EnerVista VP Monitoring/ViewNodes v8.16

Release Notes

Publication Number: GER-5020

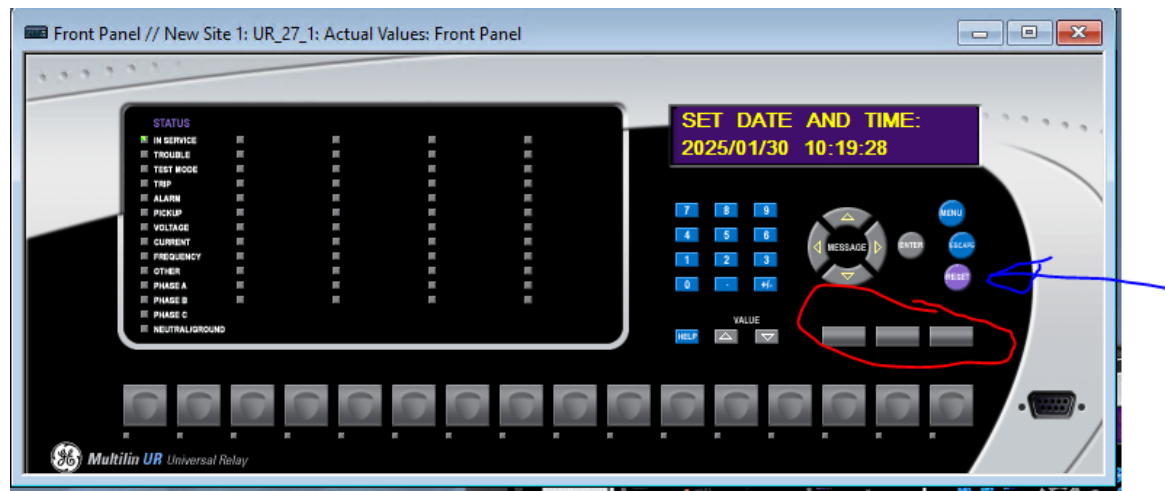
E Enhanced UR K Type Front Faceplate Push button capability

Updates to provide functionality for UR K type front panel in addition to current functionality for existing L and P type front panels.

In EnerVista Viewpoint Monitoring v8.14 the red buttons (User1, User2 and User 3) were hidden.

This enhancement makes the red buttons visible and user can operate them in EnerVista Viewpoint Monitoring v8.15.

The Reset button retains its existing functionality (is visible and can be pushed)
